**Amendments to the Drawings:**

### **REMARKS**

This Amendment responds to the Office Action mailed September 19, 2005.

FIG. 2

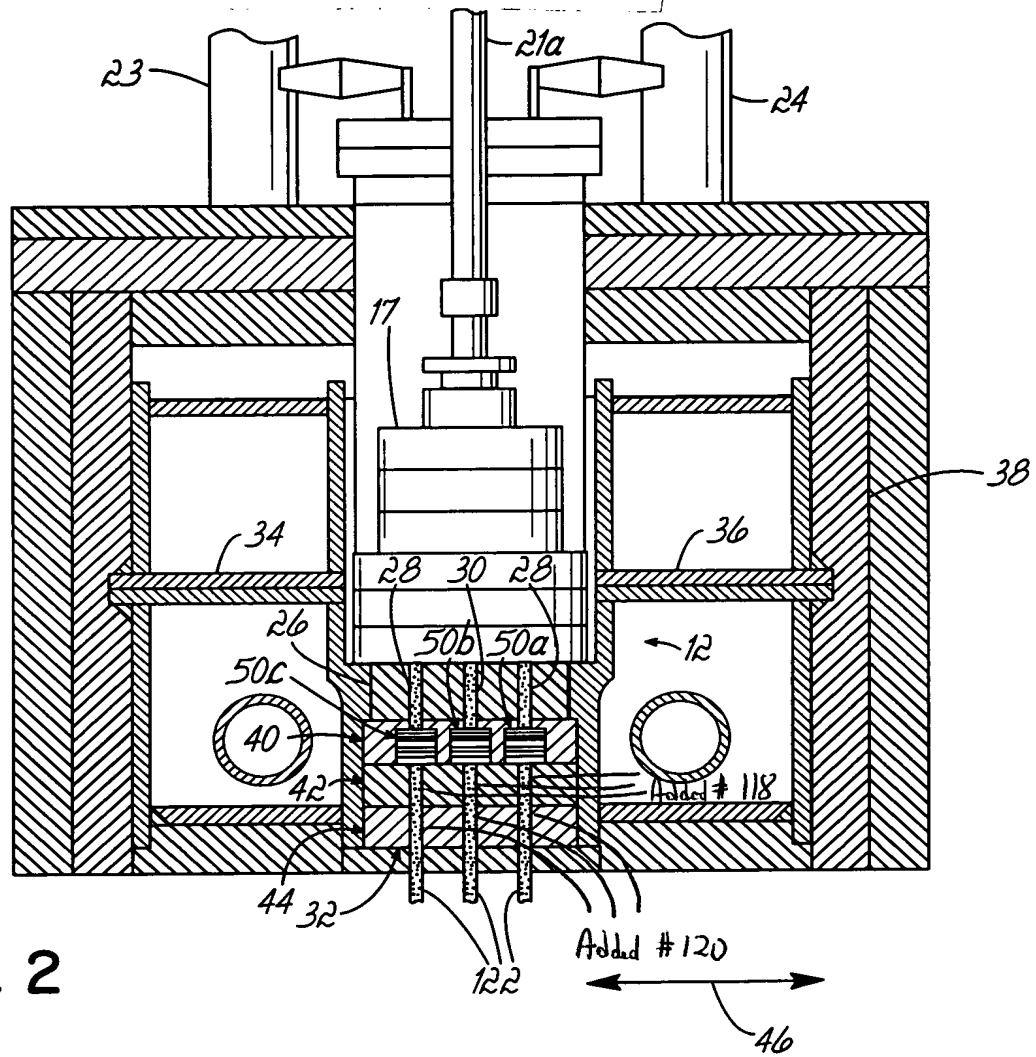
The attached sheet of drawings includes changes to Figure 2. The sheet replaces the original sheet including Figure 2. Figure 2 has been modified to add reference numerals (118) and (120).

Applicant has amended the drawings to correct a minor labeling error. Specifically, Figure 2 has been modified to add the reference numerals (118) and (120), which conforms the drawings to the written description. Applicant's specification, at the paragraph beginning at page 15, line 12, provides written description support for these drawing corrections. Applicant submits that these amendments introduce no "new matter" into the specification.
